## **Leitrim County Council**

Planning Register Ref. No. 20-C-3

Public Realm Improvement Scheme within the town centre of Mohill and to modify the curtilage /front boundary of St. Mary's Church Wall.

Public Realm Improvement Scheme, Mohill	Part 8 Planning Report

Figure 5 Figure 6

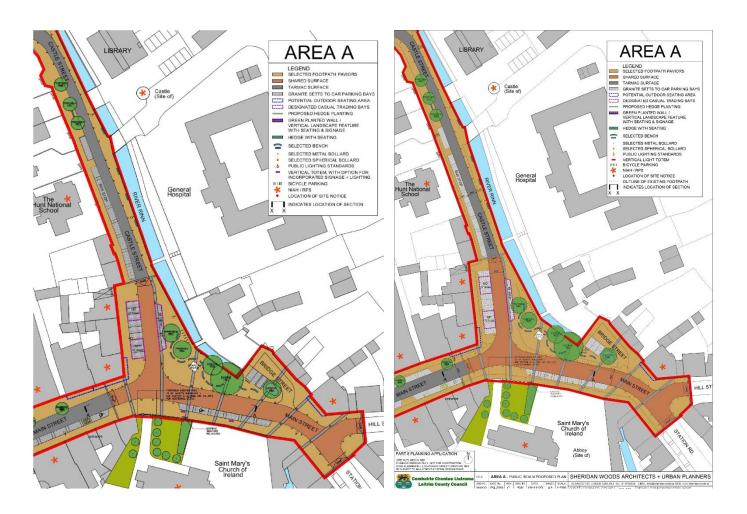
Further to a number of issues raised by the public consultation exercise, the planning authority have worked with the architects to address the issues and make modifications to this area. The modifications are as follows, and as shown in Figure 6:

- Increase of Perpendicular Carparking at the Southern end of Castle St from 9 spaces to 11
- Reduction of designated outdoor seating are at the corner between Castle St and Main St
- Reintroduction of parking
- Relocation of trees and possible street furniture accordingly
- Increase of parking at the northern side of this end of Main St (see Area C for all numbers of parking on Main St)

Figure 8

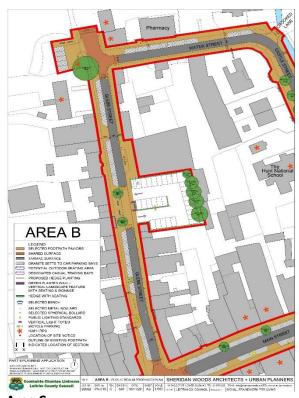
Further to issues raised in the public consultation exercise, the planning authority now propose to make modifications to that which was proposed. The modifications are as follows, and can be seen in Figure 8 below:

- The shortening of the raised platform at the northern end of Glebe St to increase parking provision at this location. 4 no. spaces will be provided, where 2 were initially proposed.
  - 2 spaces to facilitate hardware store
- At the southern end of Glebe St, the raised platform is also reduced, to make provision for carparking closer to Main St

Figure 11

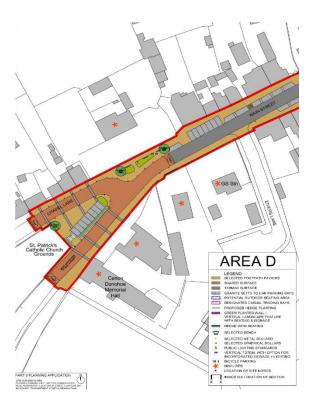
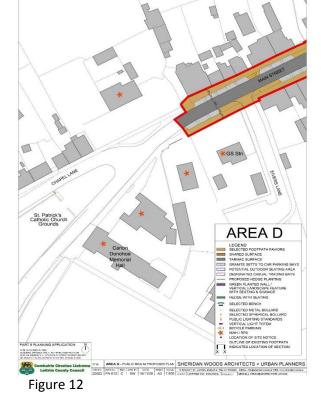
Further to a number of issues raised by the public consultation exercise, the planning authority have made significant modifications to the proposals in this area. Modifications are as follows and can be seen in Figures 11 and 12 below:

• The entire area to the west of the Garda Station has been removed from the proposal.

- The perpendicular parking on the opposite side from the Garda Station has been removed and replaced with parallel parking.
- 3 parallel spaces have been introduced in front if the Garda station
